# Work Order ID 101771

Item Name: Replacement Skidtube

| DRAWING NO.<br>D2580 | TITLE<br>205 SKIDTUBE ASSEMBLY | REV. E                  | DART AEROSPACE LTD<br>ENGINEERING ORDER |  | D.E.O. NO.<br>D2580-E-1        | SHEET NO.<br>SHEET 1 OF 1 | SCALE<br>NTS |

CHANGE ALL C'BORED WELDED CROSSBOLT SPACERS TO SWAGED SPACERS

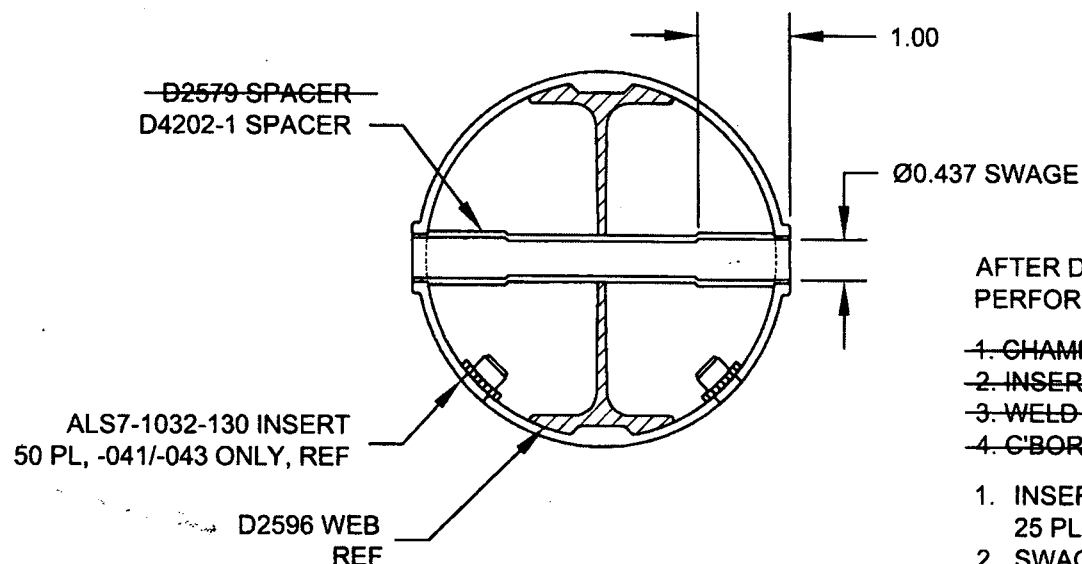
WELD 4X D2579 SPACERS PER DWG  
IN LOCATIONS MARKED "NO C'BORE".  
REF SHEET 4 OF DWG.

|    | 4  |    | * D2579 | CROSS BOLT SPACER |
| 20 | 20 | 25 | D4202-1 | SPACER            |
